Re: Minor Project Refinement No. 9 for the TL 6975 San Marcos to Escondido Project

TL6975 San Marcos to Escondido 69 kV Project CPUC Minor Project Refinement Form

Report No.: 9

**MPR-9 Figure 1
Structure Location 59
San Diego County, CA**

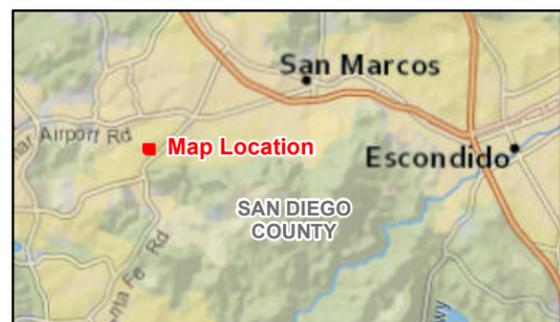
Please note, **Attachment B, MPR-9 Figure** includes the existing access road portion that travels west from the entrance to the existing non-Project related pole. This access road portion is also being proposed for use during construction activities at Location 59.

Following the field constructability review, the construction contractor identified the need to utilize additional space in order to construct the new fill slope at this location and meet specifications in the Grading Permit issued by the City of San Marcos. The proposed MPR-9 work area will be situated at the toe of a new fill slope once the graded pad is installed (permanent work area). In addition, the temporary work area will allow construction crews to maximize available space, and safely and efficiently perform the pier foundation and pole installation activities at this location.
